Transport for NSW

Central Precinct Western Gateway Rezoning Proposal

Response to Submissions Report

July 2020 | FINAL

Figure 7. Results around areas between Blocks A and B with 30 metre spacing between towers (Left), and with localised amelioration measures (Right)

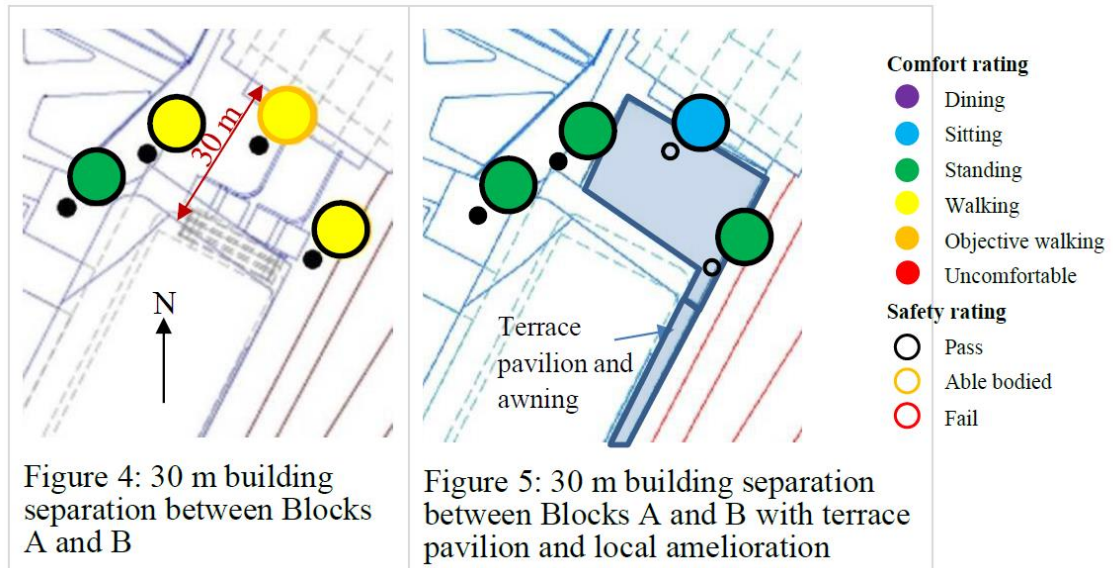
Submissions raised that building separation distances and setback requirements are to better address the interface with surrounding heritage buildings and streets and public spaces, maintain view corridors and address wind issues. The panel recommended that the proposals adopt a minimum 30m clear separation between the planning envelopes of Block A and B and specified that the additional separation to achieve the 30m should be accommodated on Block B.

Wind conditions were modelled for the area between Blocks A and B with the results from the wind tunnel testing indicating that the proposed 30 metre separation between Block A and B towers was insufficient in its own right to meet the relevant safety criterion (refer to **Figure 7**).

In response to this issue, the draft Design Guide for the Western Gateway has been amended to specify a minimum 30 metre separation Blocks A and B. The proponent for Block B acknowledge and support recommendation to accommodate additional building separation without the loss of GFA. The 30m has been accommodated within Block B.

However, the study found that combining the 30m building separation with the inclusion of localised amelioration measures such as a terrace pavilion between Blocks A and B, wind conditions would significantly improve and provide acceptable levels for the intended use of the space (refer to **Figure 7**). An awning along the eastern façade of Block B building combined with a Terrace Pavilion would further improve wind comfort and safety criteria in this location.

Figure 8. Results around south-west corner of existing conditions (Left), with 6 m setback to Lee Street (Centre), and with 6 m setback and amended geometry (Right)

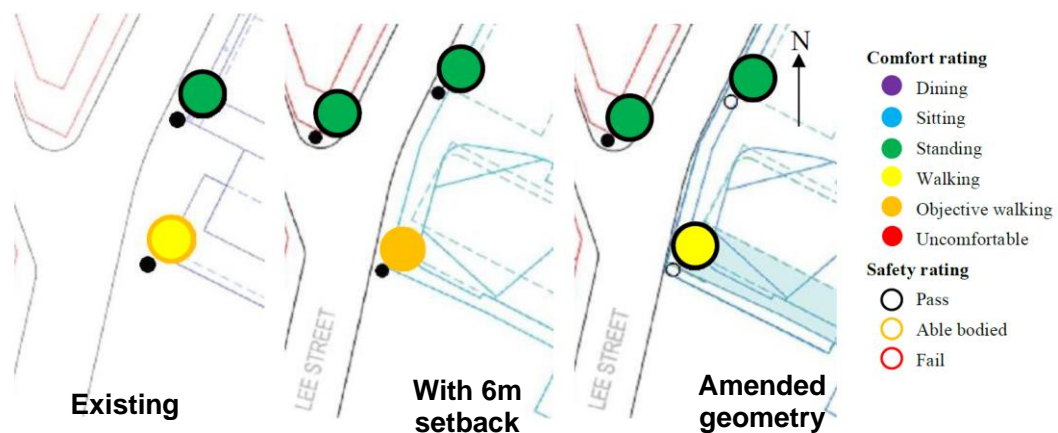
With regard to the suggested six (6) metre upper level setback from Block B podium fronting Lee Street. Wind tunnel testing undertaken by ARUP concluded that acceptable wind conditions for comfort and safety could be achieved through appropriate design and architectural interventions. It noted that the south-west corner of Block B currently experiences wind conditions that exceed the relevant safety criterion, and that the suggested 6 metre setback to Lee Street resulted in wind conditions around the south-west corner of the sub-precinct to become measurably worse.

In response to this, further testing was undertaken to identify the most effective design solution to improve wind conditions whilst maintaining the tower envelope and keeping within the envelope controls. The outcome of this testing confirmed that the most effective strategy for mitigating wind impacts along Lee Street was to block the southern colonnade of the building on Block B and wrap an awning around the buildings south-west corner to Lee Street. With these amelioration measures, the wind conditions around the south-west corner were improved to be better than the existing conditions and maintained similar conditions along Lee Street.

With the above in mind, further testing undertaken by ARUP confirms that the most effective solution to improve wind conditions whilst maintaining the tower envelope and keeping within the envelope controls, is to block the southern colonnade of the building on Block B and wrap an awning around the south-west corner. With these amelioration measures, the wind conditions around the south-west corner were improved to be better than the existing conditions and maintained similar conditions along Lee Street (refer to Figure 8).

Figure 9. Existing wind conditions compared to results around cumulative wind assessment with Blocks A and B

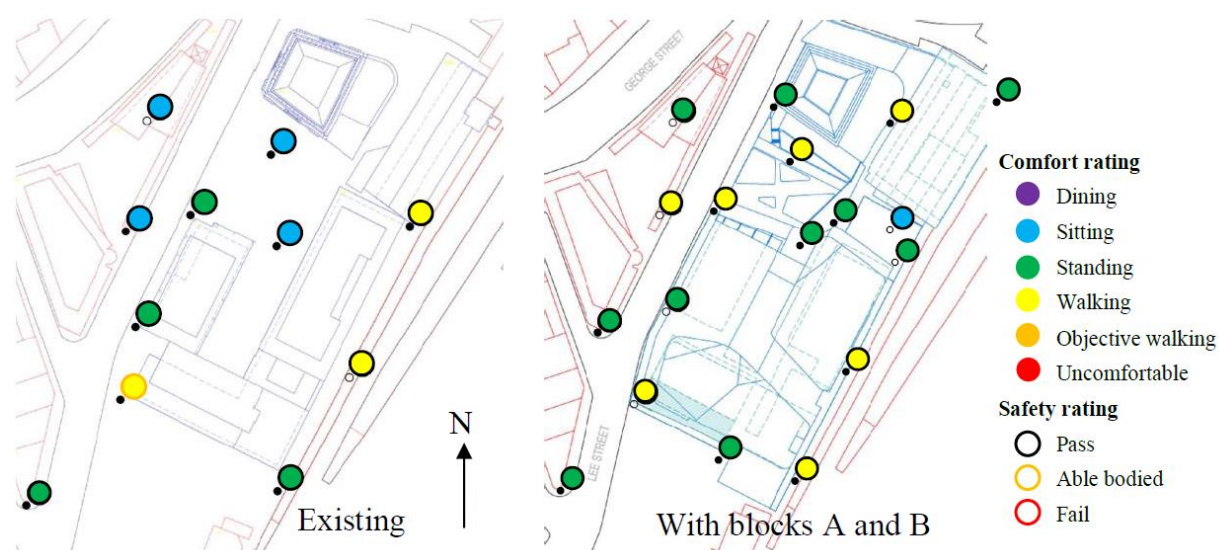
Further detailed cumulative wind testing under a developed scenario for Blocks A and B was undertaken of the proposal in response to the matters raised by the City of Sydney and the Project Review Panel, and confirmed that:

Overall, the cumulative impacts of Block A and Block B developments have been assessed and can meet appropriate wind comfort and safety conditions for the intended use of the spaces, without reliance on temporary structures to mitigate wind impacts. Architectural interventions (at DA stage) provide the greatest form of mitigation and ability to achieve acceptable wind comfort and safety criteria for the intended purpose.

A cumulative wind analysis of Blocks A and B has been undertaken by both proponents and confirms that acceptable wind conditions can be achieved within and around the sub-precinct that is consistent with a CBD scaled environment. As shown in **Figure 9**, wind testing confirms that comfort ratings can be achieved that support walking through to sitting within and around the sub-precinct. Inevitably, wind conditions will change due to the proposed Western Gateway sub-precinct, but importantly the cumulative wind assessment confirms that all areas within and surrounding the sub-precinct achieve safety ratings that pass the relevant criteria. Importantly it is noted that both ARUP and Windtech have undertaken independent cumulative wind assessment using the same building envelope models and have arrived at generally consistent conclusions with regards to the wind effects within and surrounding the sub-precinct.
